Historic Resources Board

Staff Report (ID # 12015)

Summary Title: 819 Ramona Street (Zion Church)

REGARDING 819 Ramona Street – Secretary of the Interior’s Standards Compliance Analysis

Figure 3: Proposed east (rear) elevation.

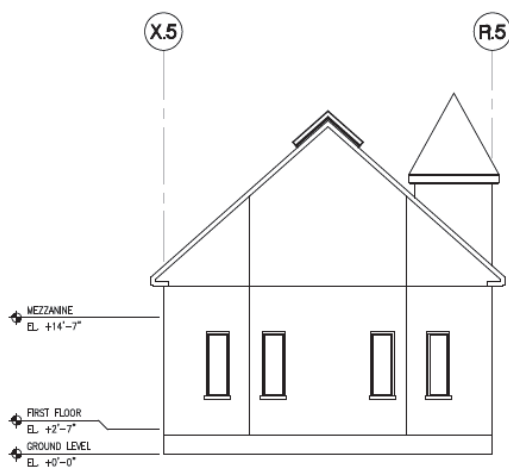
The four windows that are proposed to be installed at the east façade will be approximately 2'-6" wide and 7'-0" high and will be arranged in pairs along the rear wall of the building (**Figure 3 and Figure 4**). Unlike the existing historic windows, the proposed windows will be fixed sash with clear glass to allow more light into the building and to differentiate the new windows from the historic leaded amber glass windows. As stated earlier, the proposed new windows are located along a rear façade, facing an adjacent building over a paved areaway, and will not be visible from the public right-of-way.

Discussion: The proposed project does not propose any work that would destroy or alter the character-defining features of 819 Ramona Street. In areas where work is undertaken – to install new windows at the east façade and a roof ridge skylight – the alterations are differentiated in design, finish, and materials from the historic resource. The rear windows are designed to be a different dimension, material, and finish to clearly differentiate them from the building's original leaded amber glass windows. The roof ridge skylight is recognizable as a contemporary design and will be finished in contemporary materials. The design will be sensitive and compatible with the building's roof design as it follows the pitch and form of the gable roof, and has a relatively low profile that is set back from the primary façade to remain unobtrusive. In addition, the skylight has been sized and placed to remain referential to the historic resource and not to overtake the design and form of the existing roofline.

Figure 5: Proposed west elevation (primary façade).

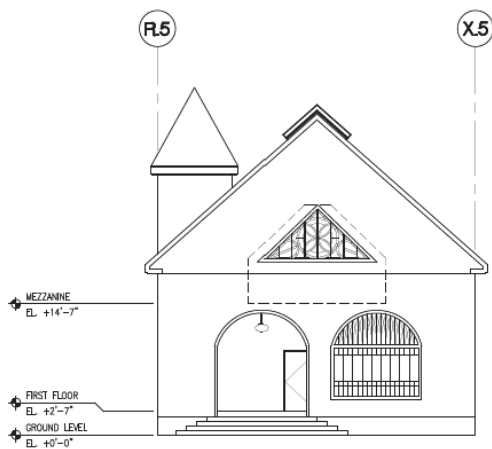
The roof ridge skylight, sized at approximately 7'-6" by 11'-2 1/2", will be located just east of the centerline of the roof in order to align with the internal roof bay structure and allow for a setback from the primary façade (**Figure 5 and Figure 6**).

While the cladding material of the roof is not original, the form, massing, and pitch of the roof is a character-defining feature of the building. The proposed skylight will retain these features to a high degree as it follows the form and massing of the roofline, and it will not change its overall design, form, or pitch. The skylight itself will cause a height increase of approximately 9" to accommodate its framing and waterproofing.

This feature will be visible from the public right-of-way when viewed from a strong oblique angle. Due to the presence of an adjacent building to the north (along Ramona Street), and due to the

relatively narrow width of Ramona Street, the skylight is only partially visible when seen from the north, and somewhat more visible when seen from the south (looking away from Channing Avenue).
